TECHNICAL BULLETIN

NO. 407-97-4

MODELS AFFECTED: 407

SUBJECT: **AFT ENGINE FIREWALL COVER**
206-064-902-137, REPLACEMENT OF.

Figure 1. Replacement of cover.

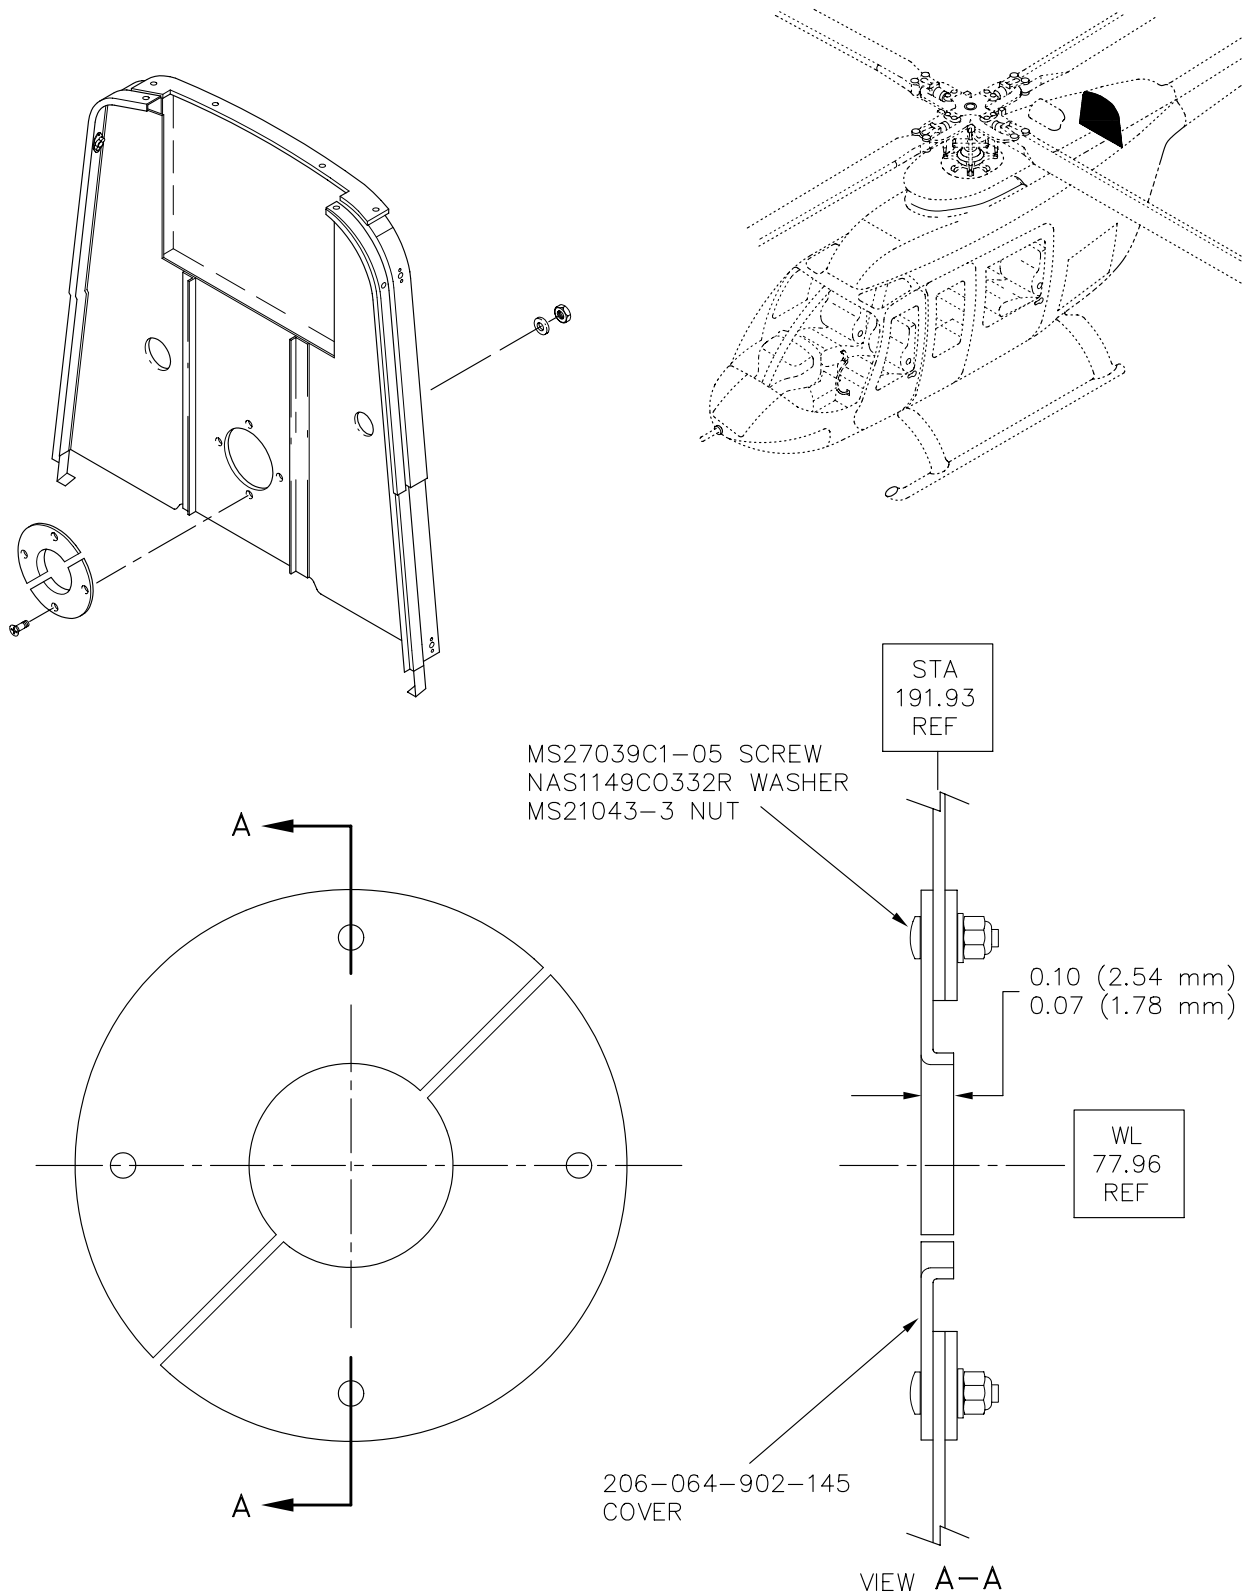
DESCRIPTION: Bell Helicopter has found that the original configuration cover half P/N 206-064-902-137, installed on the aft firewall of the engine compartment, can permit contact between the cover flanges and the oil cooler blower shaft.

A new design cover half P/N 206-064-902-145, has been made and includes a lower profile flange which gives the necessary clearance (Figure 1).

6. Put the new cover P/N 206-064-902-145 in position on the aft firewall. Install the new screws P/N MS27039C1-05, washers, and nuts.
7. Install the aft fairing assembly and secure the engine compartment cowlings (Refer to BHT-407-MM-5, Chapter 53).
8. Make an entry in the helicopter historical record to show that this Technical Bulletin is completed.
9. Make an entry in the Record of Technical Bulletins in the Illustrated Parts Breakdown.

Figure 2. Oil cooler blower shaft - Inspection

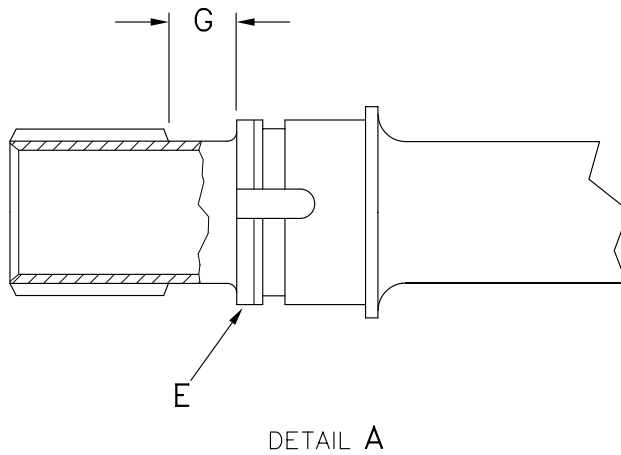
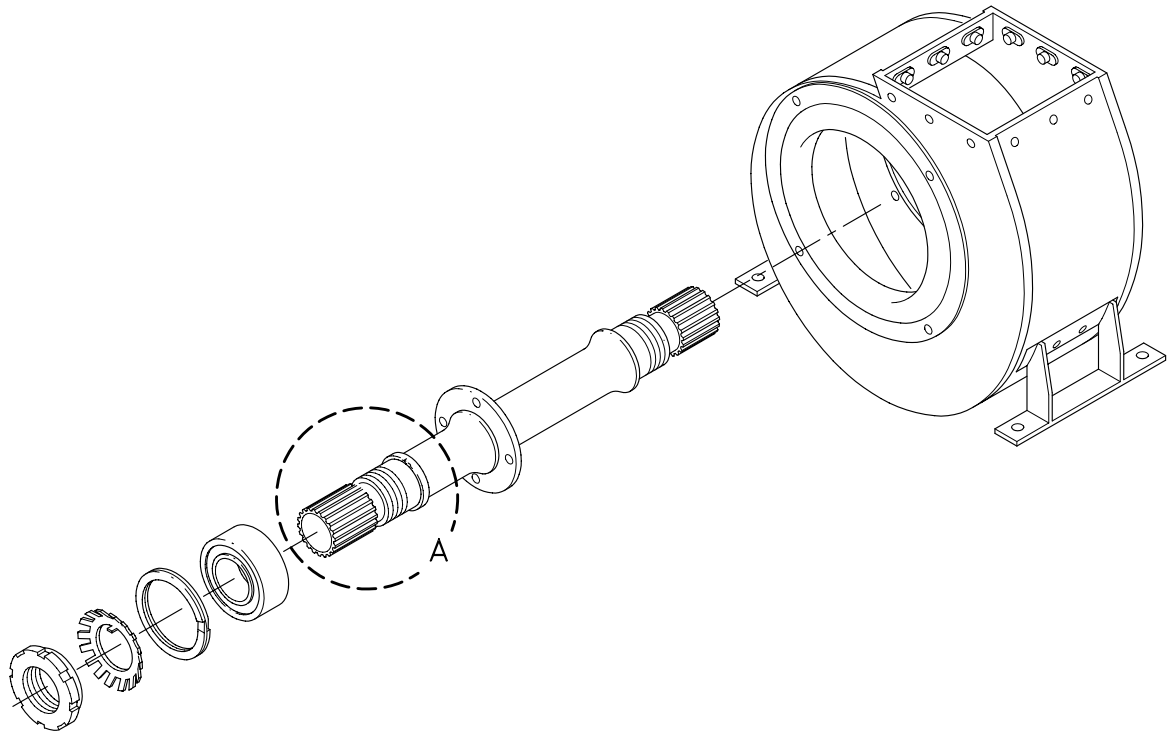
Inspect shaft body outside diameter area G and E
(Refer to BHT-407-MM, Chapter 65, Oil cooler
blower shaft - inspection).
